NUMBER: S.I. M20-61A

SUBJECT: START POWER ENGAGED WARNING CIRCUIT MODIFICATION.

MODELS/S/N's AFFECTED: Mooney M20J S/N's 24-1214 thru 24-1326, Mooney M20K S/N's 25-0613 thru 25-0711.

FIGURE 1

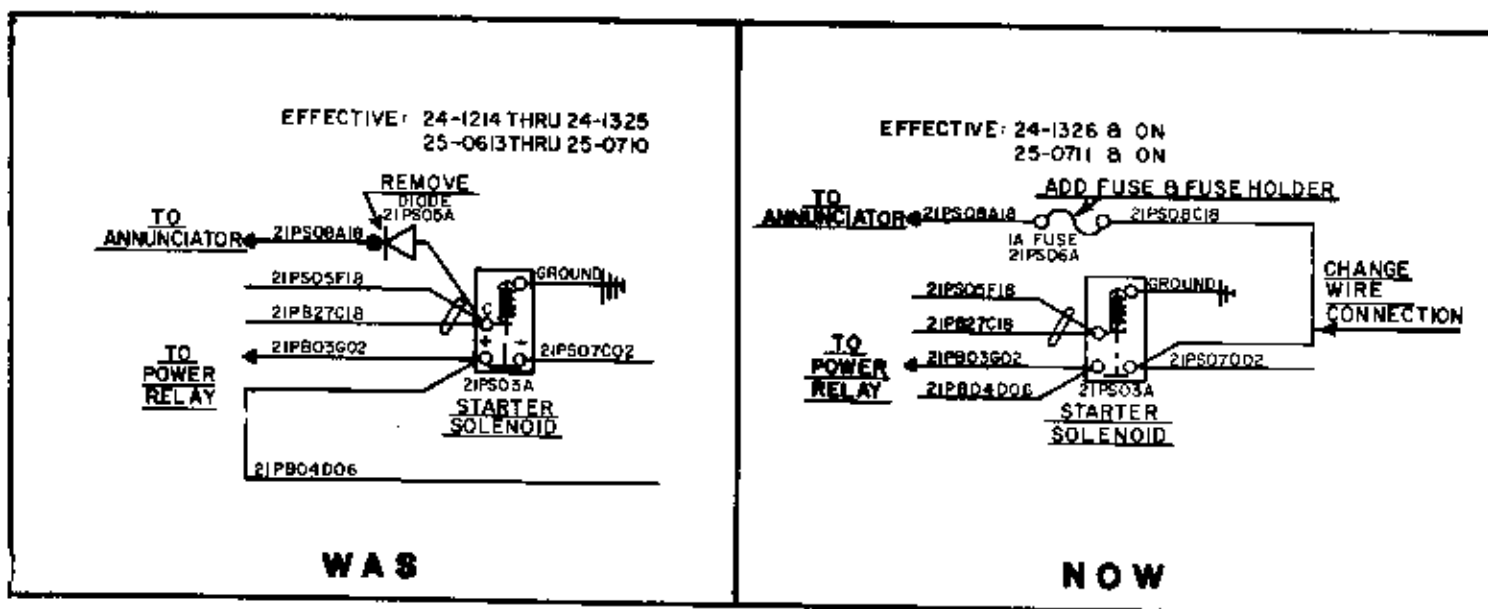
INTRODUCTION: The M20 series aircraft listed above have a starter motor electrical power engaged warning system installed. The warning system annunciator panel will illuminate "start power engaged" during normal operation of the starter switch or if a short occurs in the starter switch circuit. The warning system will not illuminate if the starter relay contacts stick in the shorted position.

A change to the wire connections at the starter solenoid will allow the annunciator to illuminate in any case where a malfunction may supply power to the starter.

INSTRUCTIONS: Reference Figure 1 "was" illustration for current configuration and identification of wire no. 21PS08A18 and diode no. 21PS05A. This wire must be disconnected and soldered to fuse holder as shown in Figure 1 "now" configuration. The diode shown in "was" illustration must be removed and discarded. Connect wire no. 21PS08C18 to the inline fuse holder and starter solenoid terminal as shown in the "now" illustration.
